One Roof site visit: field companion

High Street, Princes Town · Lot RP1 · printed from the drawing set of 2026-04-11 and our 3D model · prepared 2026-07-30

Sheet 1 of 9 · A2 SITE PLAN

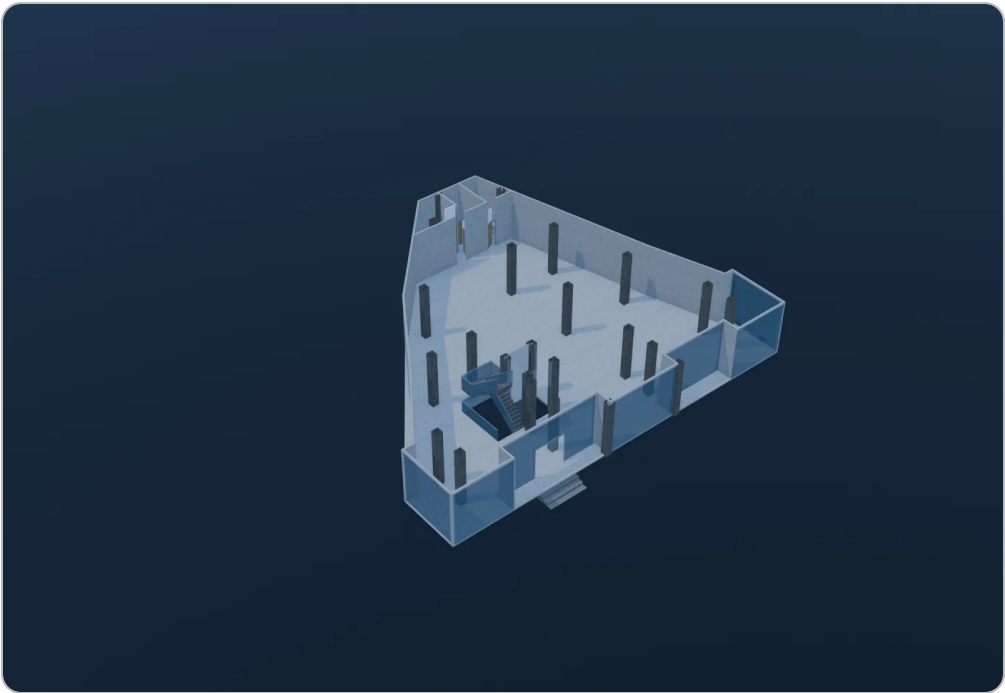
ON THIS PAGE	STATUS
Three boundary retaining walls, printed "Retaining Wall to Engineer Specs."	NO DIMENSIONS GIVEN. W-N 141'-3", N-E 17'-2 3/4", E-S 115'-4 1/4" long, but nothing vertical at all. This is why you measure them
8 apron parking stalls, drawn	Never extracted into the model. Count what is actually marked out
Loading bay 18'-0 1/2" x 10'-11 1/4"	RETIRED. It was a false pairing of two unrelated dimensions. The real zone is about 25'-0" x 12'-0" with a divider
A vertical line at about x33 through the rear tip	OPEN. Logged literally as "drain? joint?". Look down and tell us which
Apron edge lines, and the 11'-3 3/4" rear kerb dimension	OPEN referents. Nobody knows which real line they point at
"Driveway around building to be structural slab on top of retaining wall"	Printed twice. Photograph that joint square on

Sheet 3 of 9 · A4 GROUND FLOOR (retail)

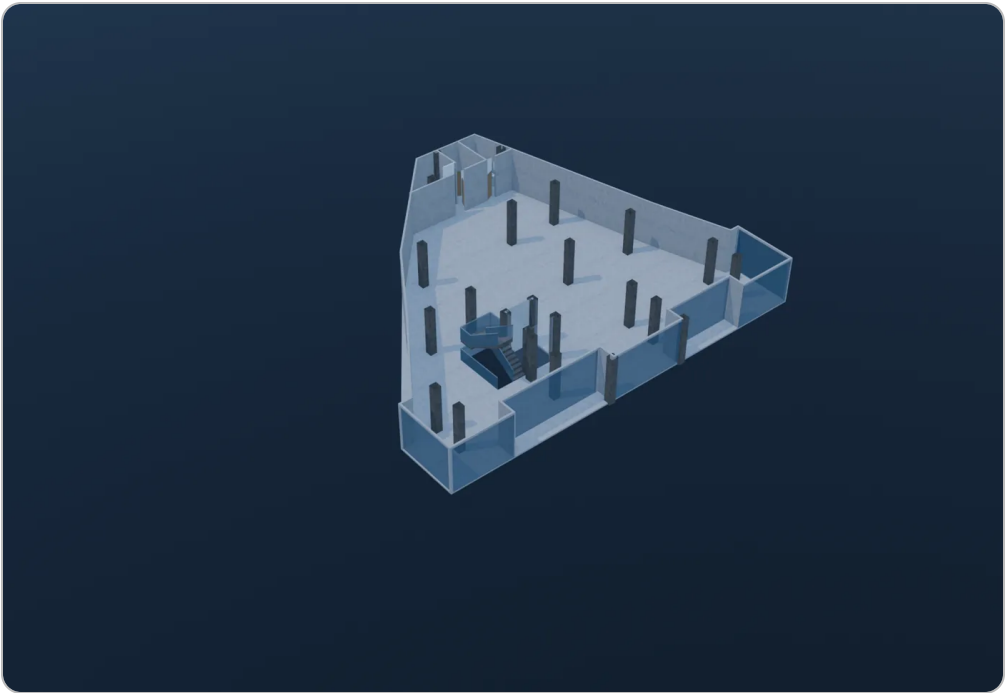
ON THIS PAGE	STATUS
Stair label reads "Dn to Ground Floor" ON the Ground sheet	DRAFTING ERROR. It should say Lower Ground. The mistake repeats on every floor sheet: the Dn label names the sheet's own floor instead of the destination
"FEMALE WASHRCOM"	TYPHO on the sheet. Harmless in itself, but it tells you the set was not proofread
Red 45-degree hatch, "Addition Shaded in Red"	The whole Ground enclosure is the ADDITION. The EXISTING part is the column frame
Storefront plane vs the A2 front-strip line	OPEN. The two sheets disagree by about 0.85 ft. Photograph the frontage square on
"5in Thk. FLOOR SLAB, See Engineering Drawings For Details"	Printed at every level. Ask for those engineering drawings. This set carries the thickness but not the reinforcement

Sheet 4 of 9 · A5 FIRST FLOOR

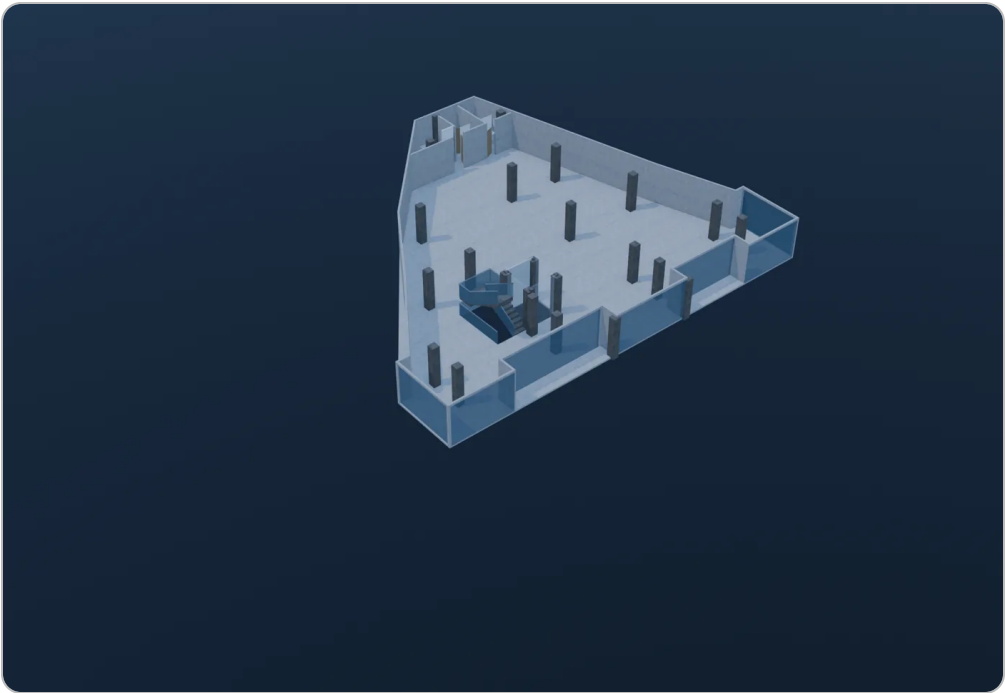
ON THIS PAGE	STATUS
Drawn IDENTICAL to Ground	485 line segments per sheet, zero unmatched . It is a copy
Ground-level shopfront doors repeated up here	DRAFTER DUPLICATION, your ruling. The elevations show doors at GROUND ONLY. The glazing IS real at all three floors; the doors are not
Tag "03. RETAIL AREA, 72'-10" x 93'-6", 4623.0 ft2"	Printed. First floor is retail too

Sheet 5 of 9 · A6 SECOND FLOOR

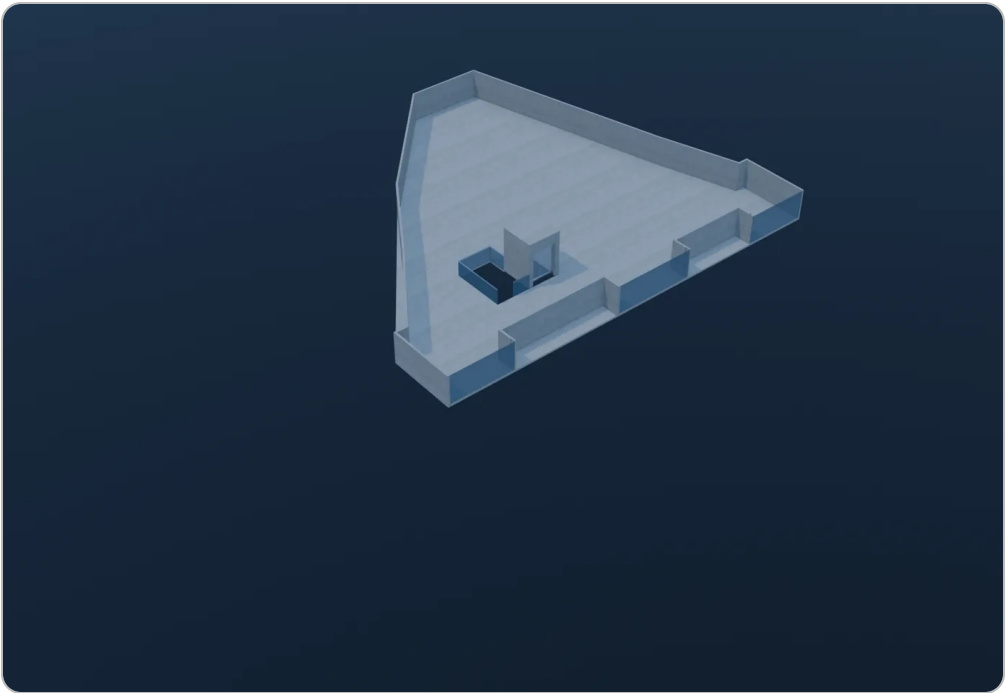
ON THIS PAGE	STATUS
Identical to Ground again	Same 485 segments, same duplication, same doors that should not be there
Tag "04. STORAGE / ASSEMBLY AREA, 72'-10" x 93'-6""	No area value printed, unlike Ground and First. Another sign of a rushed set
Stair reads "Up to Third Floor"	There is no third floor. That is the drafter's name for the roof

Our model's roof deck and parapet.

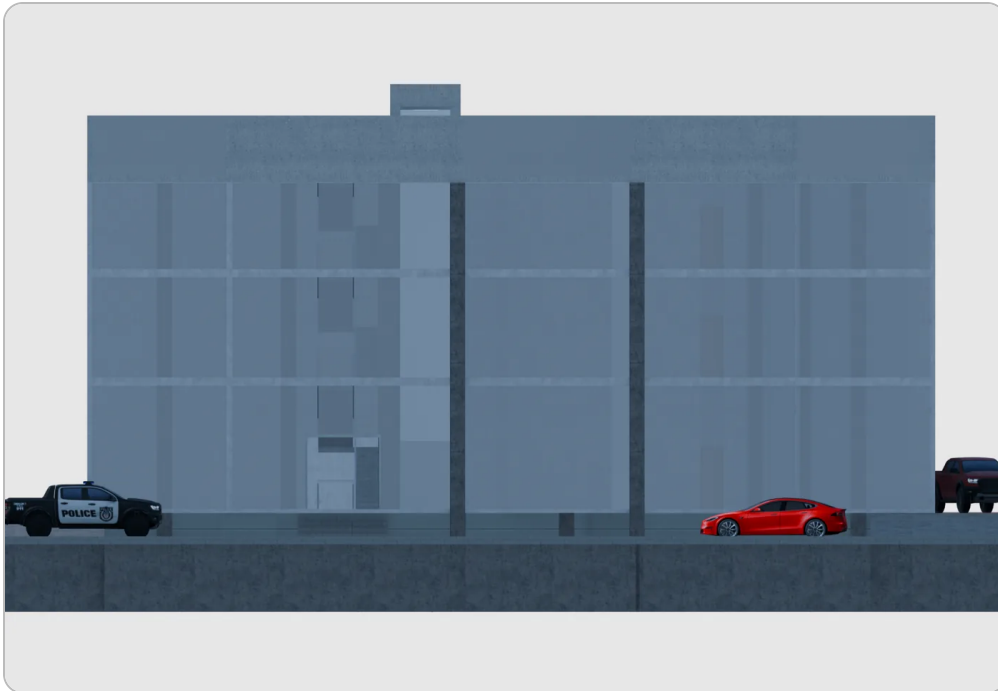
ON THIS PAGE	STATUS
Caption says "THIRD FLOOR PLAN", tag says "05. OPEN CONCRETE ROOF"	THE PAGE CONTRADICTS ITSELF. The tag is right. There is no third floor, it is an open deck with a 7'-0" parapet
A washroom dimension chain printed below the tip	LEFTOVER. There are no washrooms on the roof. Copied from the floor sheet and never deleted
Two "Fixed Glass" labels	LEFTOVER. There is no glass on this sheet either
Tag 84'-2" x 93'-6", bigger than the floors' 72'-10"	Not an error. Different referent: front face to tip, where the floors measure front face to washroom wall. Same envelope
Our model's roof slab	OUR defect, not the drawings'. The slab edge sits outside the parapet by about 2'-6" west and 2'-10" east. Being fixed on our side
